Access Compliance Report Public Rights-of-Way (Curb Ramps)

Main Street: CLUB_TERRACE_DR Cross Street: YORBA_LINDA_BLVD Location: SE

ADA ID: RPAT210923081515 Ramp Type: Type 4 - Parallel Initial Pass/Fail: Pass Overall Compliance: No Severity Score: 0

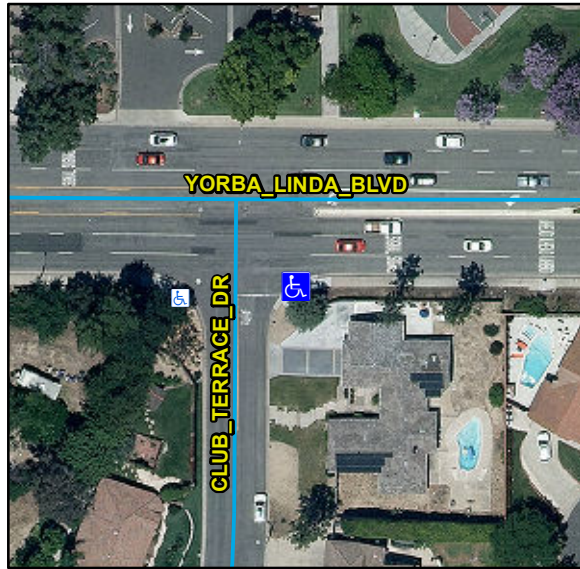
Compliance	Description	Data	Compliance	Description	Data
N/A	Ramp Length LT (in)	109	N/A	Ramp Length RT (in)	98
Yes	Ramp Width LT (in)	54	Yes	Ramp Width RT (in)	54
Yes	Ramp Run Slope LT (%)	6.8	Yes	Ramp Run Slope RT (%)	3.6
Yes	Ramp Cross Slope LT (%)	1	Yes	Ramp Cross Slope RT (%)	0.9
N/A	Landing Present	Yes	Yes	DWS Provided	Yes
N/A	Landing Length (in)	53	Yes	DWS Contrast	Yes
Yes	Landing Width (in)	60	Yes	DWS Length (in)	36
No	Landing Run Slope (%)	2.2	Yes	DWS Full Width	Yes
Yes	Landing Cross Slope (%)	1.5		DWS Offset Type	Single
N/A	Landing Movement Obstructed?	No	Yes	DWS Offset Left (in)	0
	Landing Movement Type	Curb	Yes	DWS Offset Right (in)	N/A
N/A	Landing Shared	No			
N/A	Clear Space	N/A			
N/A	Clear Space To Crosswalk (in)	N/A			
N/A	Marked Crosswalk 1	No	N/A	Marked Crosswalk 2	N/A
	Crossing 1 Direction	W		Crossing 2 Direction	N/A
	Marked Crosswalk 1 Width (in)	N/A		Marked Crosswalk 2 Width (in)	N/A
N/A	Ramp Inside Crosswalk 1	N/A	N/A	Ramp Inside Crosswalk 2	N/A

Remove & Replace Landing.
